HIGHWAY WORK PROPOSAL

Proposal Number: **005**

| <u>COUNTY</u> | <u>STATE PROJECT</u> | <u>FEDERAL</u> | <u>PROJECT DESCRIPTION</u> | <u>HIGHWAY</u> |
|---------------|----------------------|----------------|------------------------------------------------------------------|----------------|
| Racine | 1320-23-73 | N/A | STH 11, Wisconn Valley Way To CTH H; Wisconn Valley Way To CTH H | STH 011 |
| Racine | 1320-23-70 | N/A | STH 11, EFR to Wisconn Valley Way; EFR to Wisconn Valley Way | STH 011 |

Addendum No. 01
ID 1320-23-70/73
Added Sheet 24A
July 1, 2019

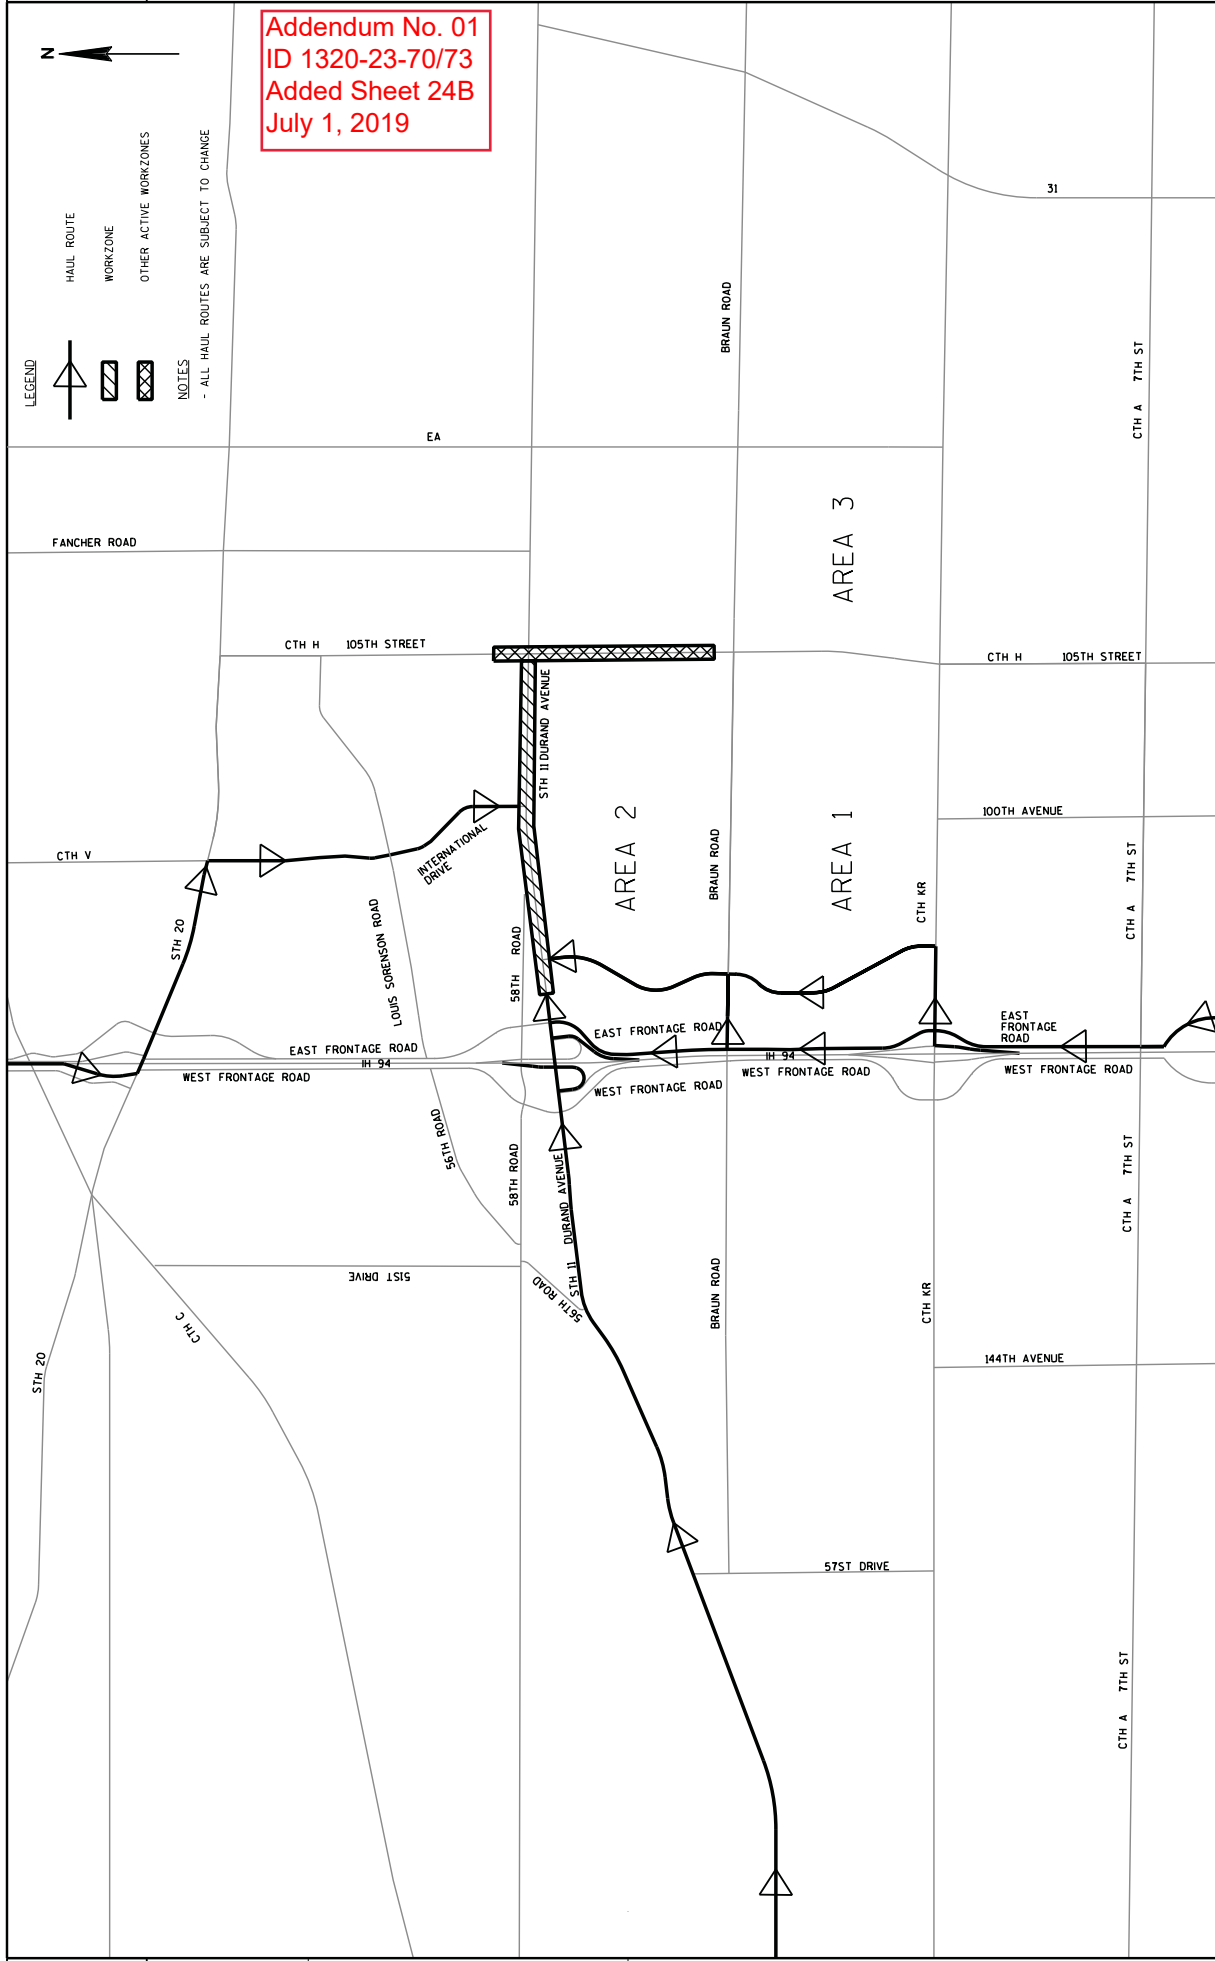
| Added Plan Sheets | |
|--------------------------|-----------------------------------------------------------------------|
| 24A | Construction Details:2019 Haul Routes (added haul route map for 2019) |
